Application No.: 10/788,953

Title: **DATA RECORDING DISK DRIVE WITH NONPLANAR PLATE SURFACES FOR DAMPING OUT-OF-PLANE DISK VIBRATION**

Pre-Appeal Brief Request for Review

**FIG. 5A****Exhibit B**

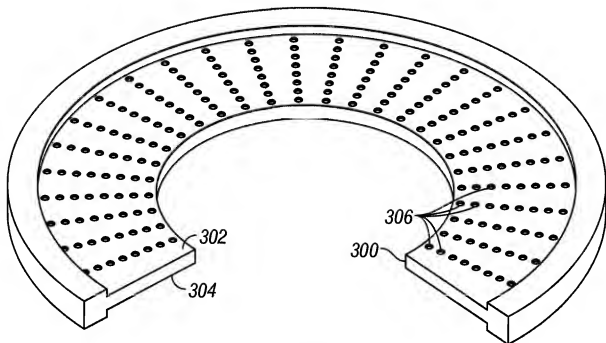
The above bold-italicized portion refers to "channels 158", which are shown in Fig. 5D of Butt et al. (Exhibit B attached). The objectionable interpretation of Butt et al. is that channels 158 are located in three discrete circumferential locations, thereby apparently reading on Applicants' "discrete circumferentially spaced-apart surface features". However, Butt et al. teaches that these are three distinct alternative embodiments. In col. 7, lines 29-37, Butt et al. states:

Actually, it is clear that the "one or more portions" referred to in Butt et al. are *not* circumferentially spaced apart portions. Rather, it is clear that they are *radially* spaced-apart portions. The quoted language from Butt et al. (col. 8, lines 20-21) refers to Fig. 5A. Fig. 5A has an "outer portion 94" and a "middle portion 98" (col. 5, line 63 to col. 6, line 7). These are

clearly *radial* portions. Thus, there is no basis for asserting that Butt et al. teaches one or more circumferentially spaced apart portions.

**FIG. 6A****FIG. 6B****Exhibit A**

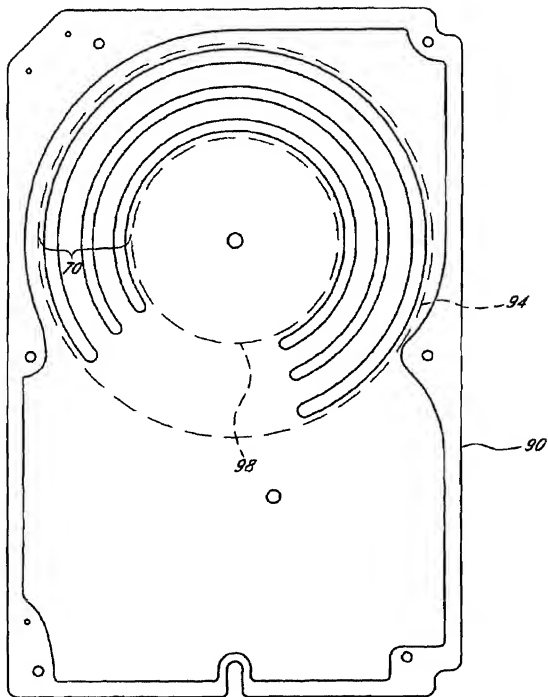
The element not disclosed by Butt et al. is the above bold-italicized portion, and is also shown in Fig. 6 (Exhibit A attached) as "circumferentially spaced-apart surface features" 306 in each of the "radially-spaced concentric rings".
